SP2025-003: Amended Site Plan for 407 W. Washington Street

TO: Planning and Zoning Commission
FROM: Bethany Ross, *Planner*
DATE: February 25, 2025
SUBJECT: SP2025-003; *Site Plan for 407 W. Washington Street*

PROJECT NUMBER: SP2025-003
PROJECT NAME: Amended Site Plan for 407 W. Washington Street
SITE ADDRESS/LOCATIONS: 407 W WASHINGTON ST

ELEVATIONS

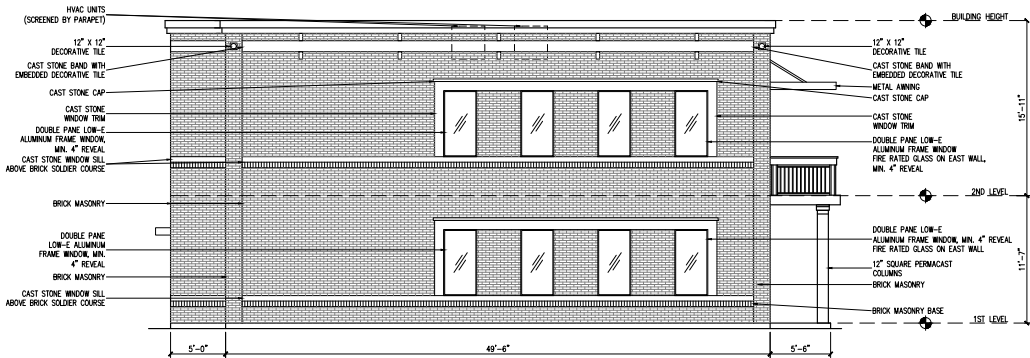
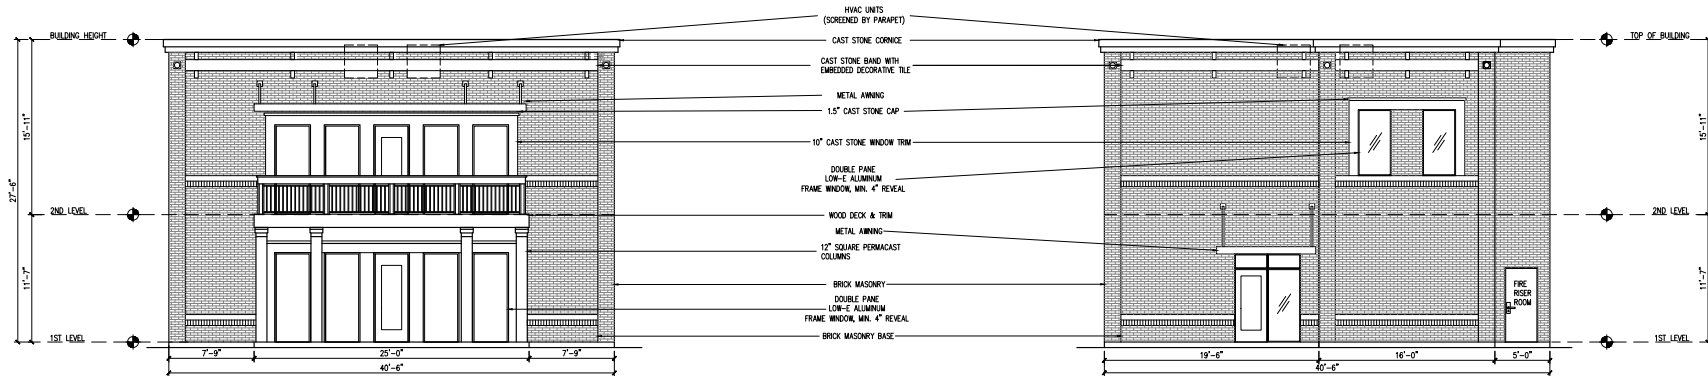
On July 28, 2020, the Architectural Review Board (ARB) reviewed the proposed building elevations and recommended that the applicant not incorporate a stone wainscot, rather use the white washed brick to meet the Downtown (DT) District's requirement of 100% brick. Additionally, the ARB recommended the columns on the front elevation be square and constructed with the white washed brick. They also recommended that the square ornamental emblems be changed to round emblems to provide more interest. The ARB will review the revisions at the August 11, 2020 meeting and forward a recommendation to the Planning and Zoning Commission.

A TREESCAPE PLAN

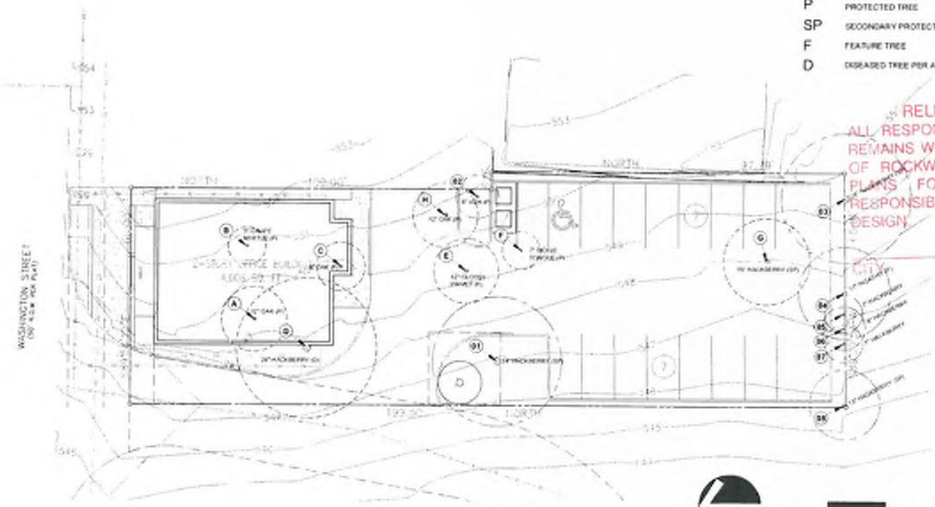
The treescape plan provided by the applicant indicates a total of 67-caliper inches to be removed from the site and the provision of one (1), six (6) inch caliper tree that counts towards the mitigation total with the proposed development. This will leave a mitigation balance due of 61-caliper inches. According to Section 05(F), of Article 09, *Tree Preservation*, of the Unified Development Code (UDC), the applicant may satisfy the tree mitigation balance by: [1] paying into the tree fund, [2] planting trees on site, and/or [3] providing the trees to the Parks and Recreation Department. In this case, the applicant has indicated their intention is to provide 20% of the mitigation balance to the City's Tree Fund totaling \$1,340.00 (i.e. 67" x 20% = 13.4" x \$100 = \$1,340.00) and providing the remaining balance of 48-inches to satisfy the mitigation balance. This has been added as a condition of approval.

- (1) All comments provided by the Planning, Engineering, and Fire Department must be addressed prior to the submittal of a building permit; and,
- (2) The applicant will be required to satisfy the outstanding balance of 48-inches of tree mitigation prior to the issuance of a building permit; and
- (3) Any construction resulting from the approval of this site plan shall conform to the requirements set forth by the Unified Development Code (UDC), the International Building Code (IBC), the Rockwall Municipal Code of Ordinances, city adopted engineering and fire codes and with all other applicable regulatory requirements administered and/or enforced by the state and federal government.

PROJECT No.	
DRAWN BY	
CHECKED BY	
DATE	09/02/2020
SCALE	
SHEET No.	of
DRAWING NAME:	
PHOTOMETRIC PLAN	
P1.0	
SP2020-017

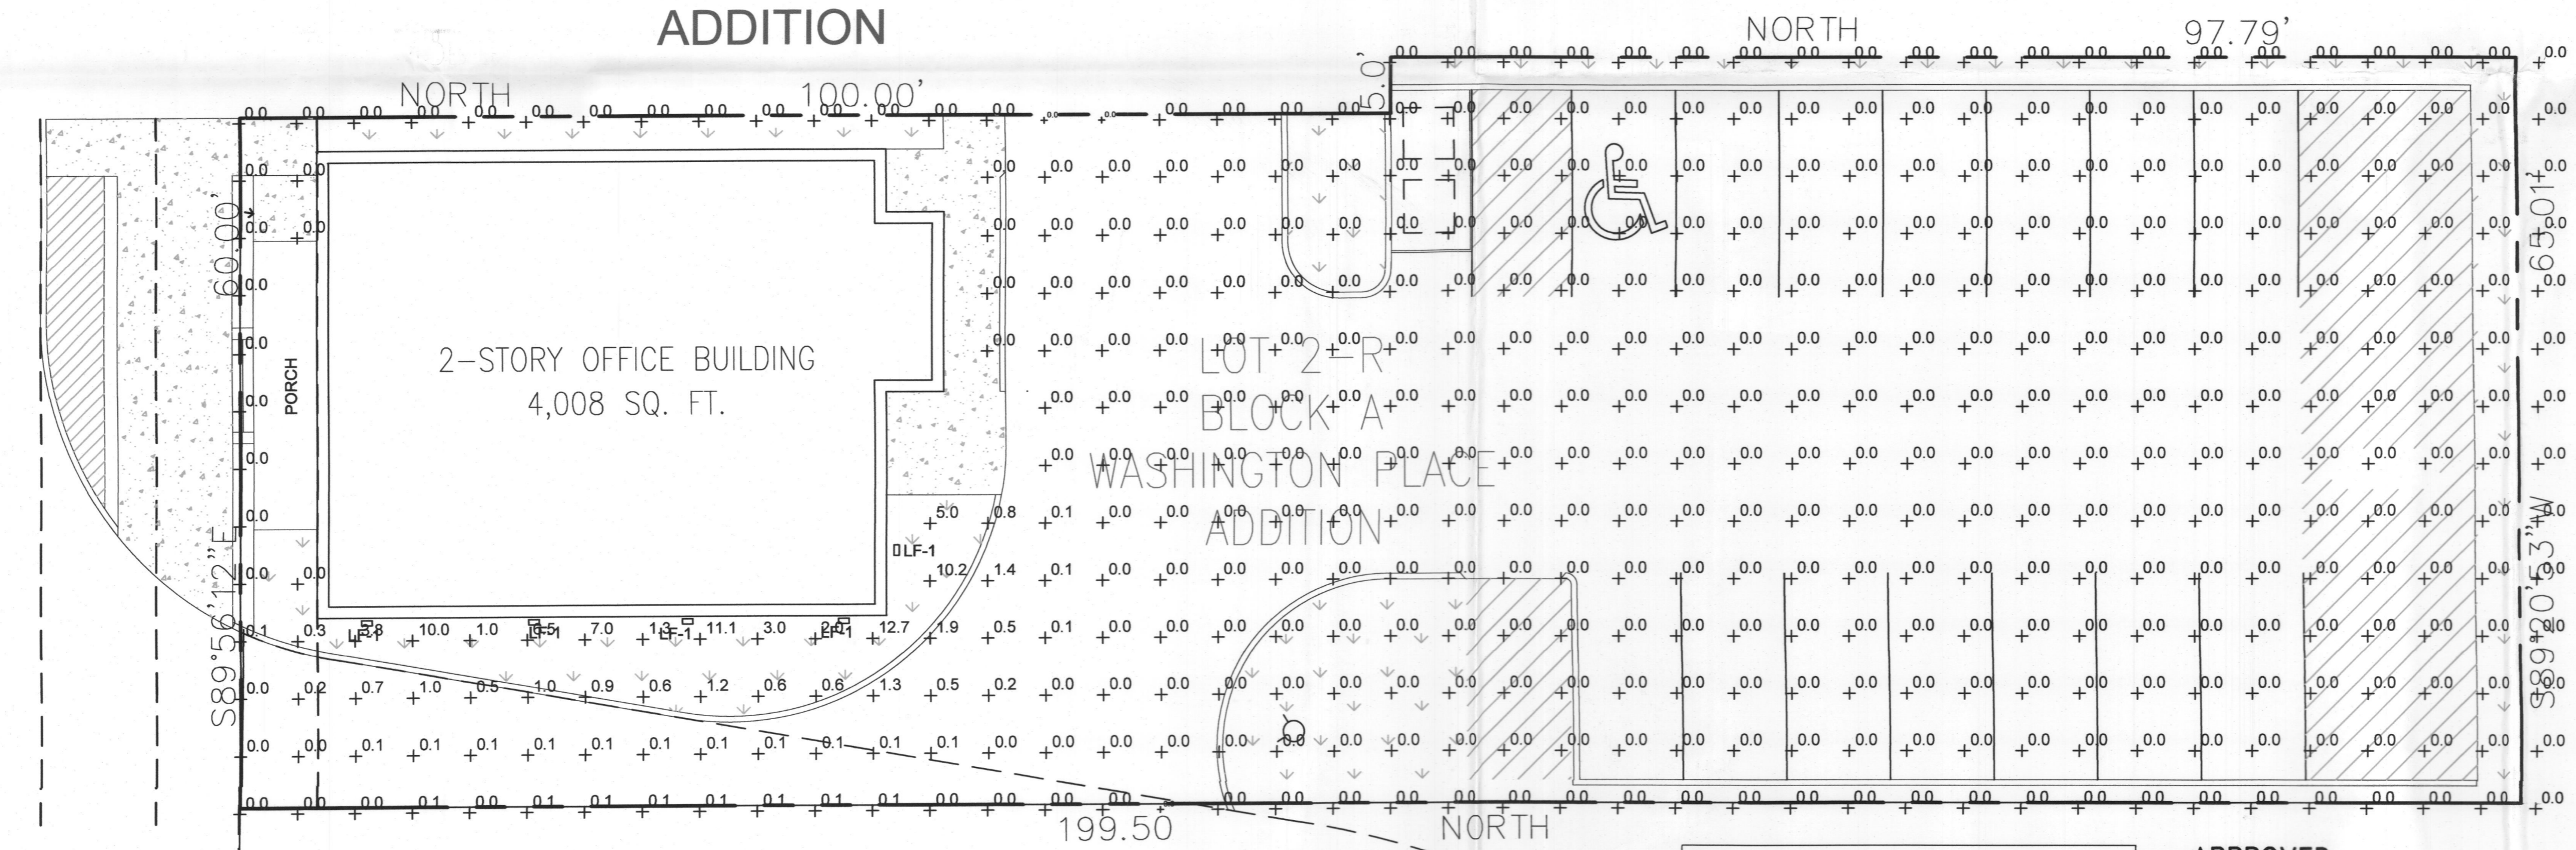
M.5 Photometric Plan. Please provide a photometric plan that meets the requirements of the UDC. The allowable maximum light intensity measured at the property line of any non-residentially zoned lot shall be 0.2 of one (1) footcandle or 0.2 FC.
